AMENDMENTS TO THE DRAWINGS

- R E M A R K S -

In the Office Communication dated October 17, 2005, the drawings were objected to under 37 C.F.R. 1.83(a). Figures 1 and 2 have been amended and Figure 3 has been added.

FIG-1

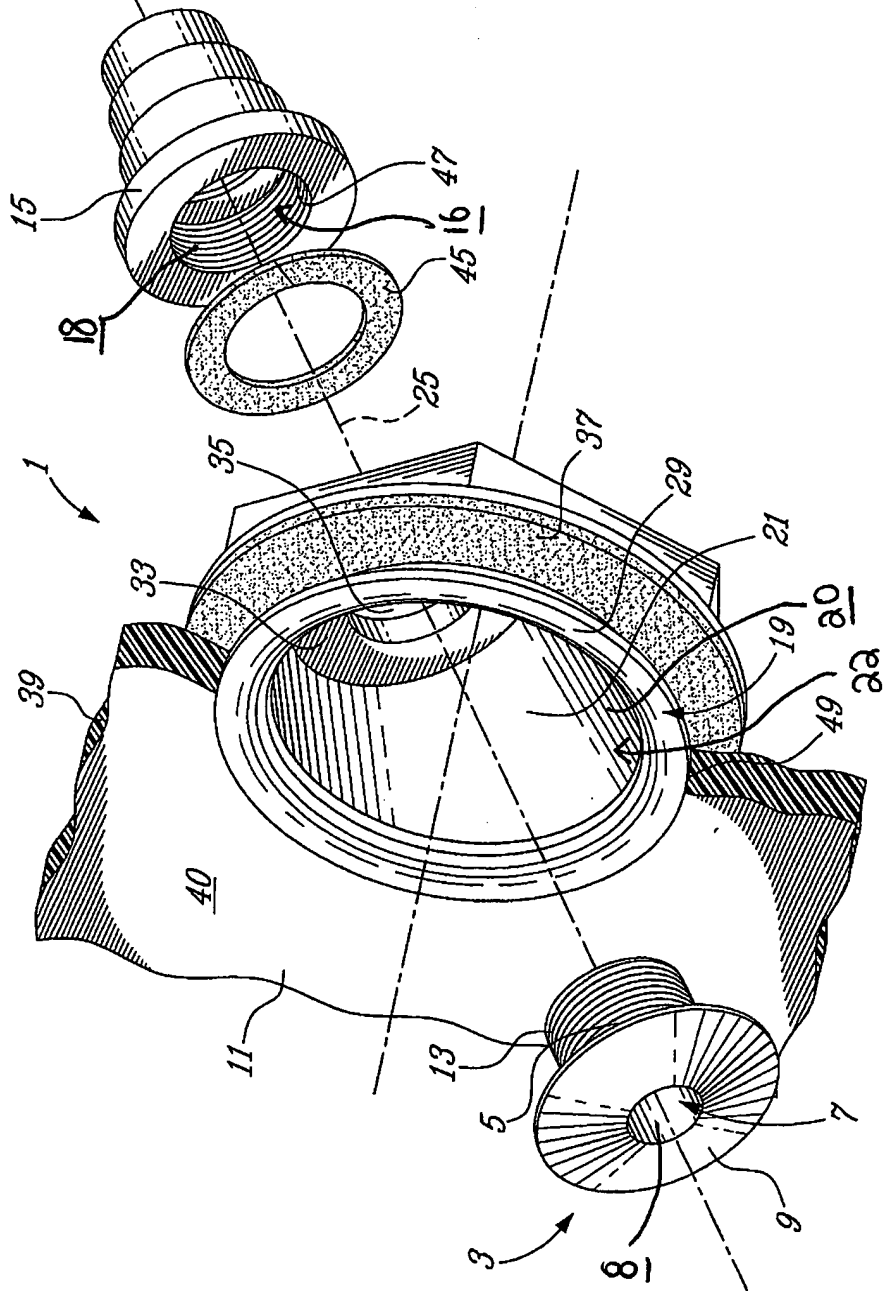
In Figure 1, the reference numerals 8, 16, 18, 20, and 22 have been added to identify the apertures 8, at opposed ends of the micro jet 3, the port 16 in the connector 15 with apertures 18 at opposed ends, and the peripheral wall 20 of the holding cup 19 which defines a cavity 22. Similarly, in Figure 2, the reference numerals 8, 16, 18, and 20 have been added to identify the same components. These components were already represented in Figures 1 and 2 and no new matter has been added.
